### **ROADWAY DESIGN BULLETIN 06-09**

**SUBJECT:** Crossovers on Limited Access Facilities

#### **2.14.4 Crossovers on Limited Access Facilities**

Figure 2.14.1  
 Crossovers On Limited Access Facilities - 6 or More Lanes  
 Typical Plan View Layout and Sections

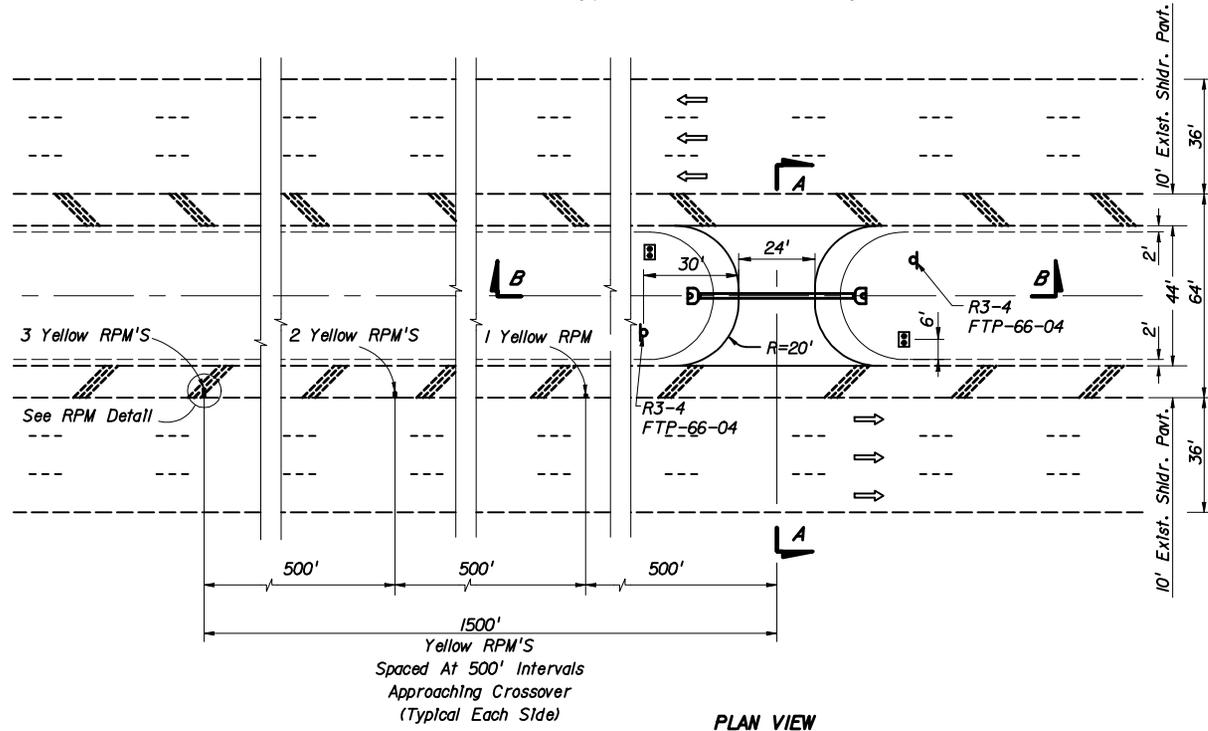
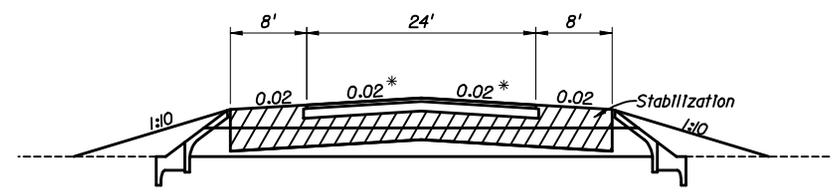
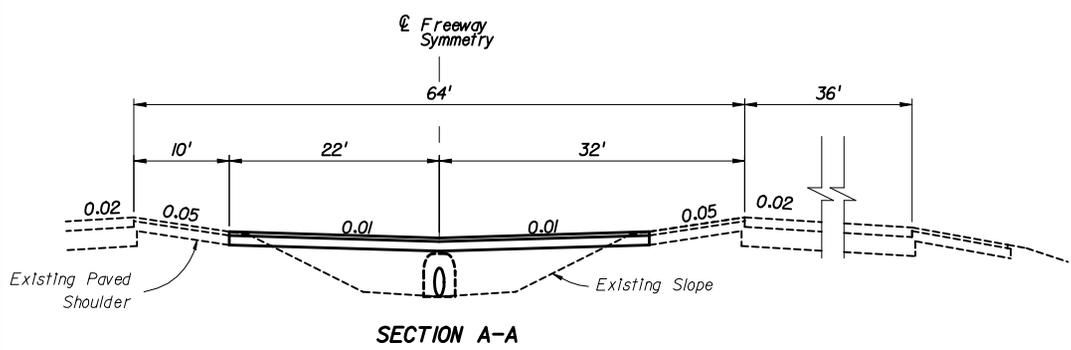
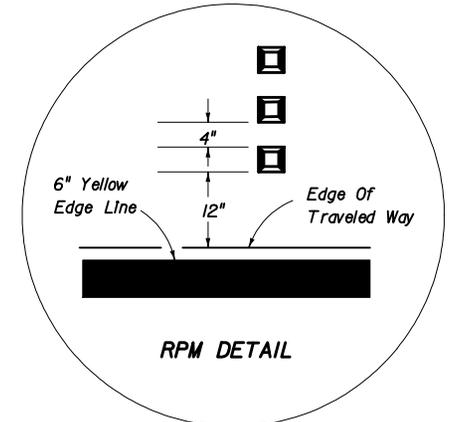
Typical layouts for the design of emergency use crossovers are provided in Figures 2.14.1, 2.14.2 and 2.14.3. These typical layouts will not cover all situations, but are provided as a guide for developing site-specific designs. Designs should accommodate the types of emergency vehicles expected to use the crossover. Law enforcement vehicles and typical ambulance sized vehicles can usually be easily accommodated. The typical layouts in Figures 2.14.1, 2.14.2 and 2.14.3 will accommodate an SU design vehicle. To the extent practical, designs should accommodate larger emergency response vehicles such as fire trucks. This will require acquiring information from local emergency responders on the size and configuration of vehicles used. Except where median widths are wider than normal, fire trucks and other larger vehicles will likely not be able to make u-turns without encroaching or crossing travel lanes. As a minimum, designs should provide for the necessary minimum radii and width to allow the largest design vehicle to enter the crossover and stop as close to perpendicular to traffic as practical. All designs should be tested by superimposing the turning path of the design vehicle to insure the crossover will operate as expected.

Signing for permanent crossovers shall consist of a "No U-turn" sign (R3-4) with an "Official Use Only" plaque (FTP-66-04). In accordance with MUTCD Section 3D.03, a double yellow delineator should be placed on the left side of the through roadway on the far side of the crossover for each roadway (see figures). To improve nighttime visibility for approaching emergency responders, install yellow RPM's placed outside the yellow edge line in advance of the crossover using the following pattern and spacing: 3 spaced 4" apart @ 1500', 2 spaced 4" apart @ 1000', and 1 @ 500' in advance of the crossover.

Figure 2.14.3  
 Median Barrier Opening For  
 Crossovers on Limited Access Facilities  
 Typical Layout

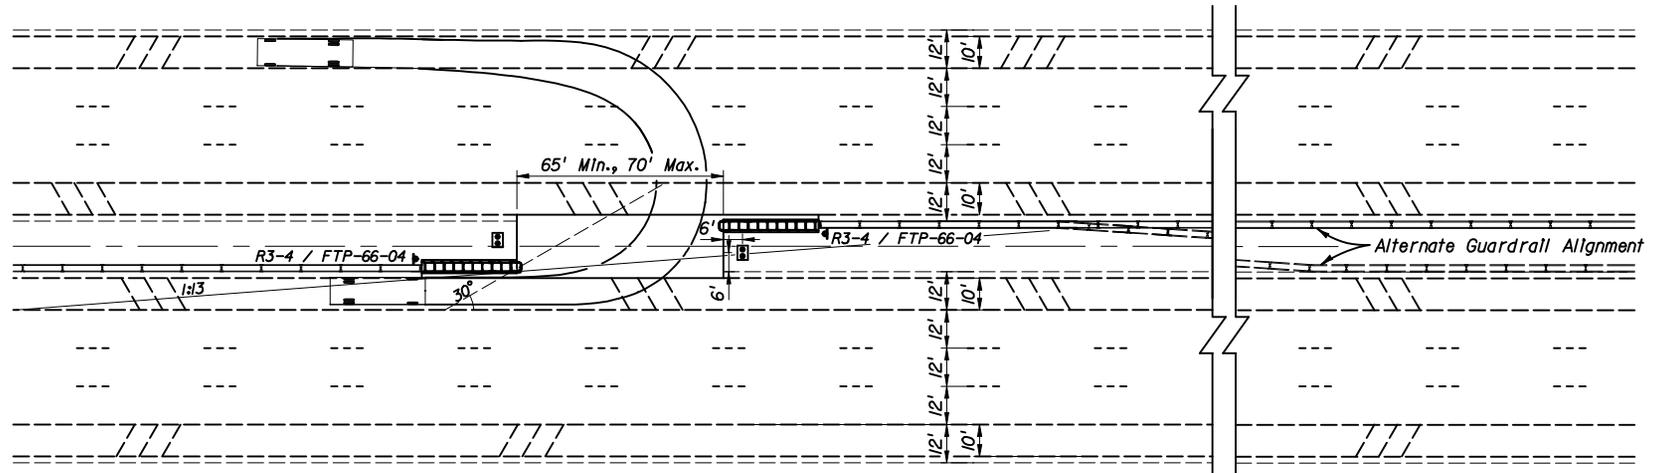
In locations where a median barrier is present, the length of the barrier opening should be minimized to the extent practical. As shown in Figure 2.14.3, the barrier ends on each side of the opening should be offset to the extent practical. Crashworthy end treatments or crash cushions to shield the barrier ends shall be provided when the ends are within the clear zone and fall within the departure angle used to set length of need. Crashworthy end treatments or crash cushions shall also be provided whenever the angle between barrier ends is less than 30 degrees measured from the direction of mainline travel (see Figure 2.14.3).
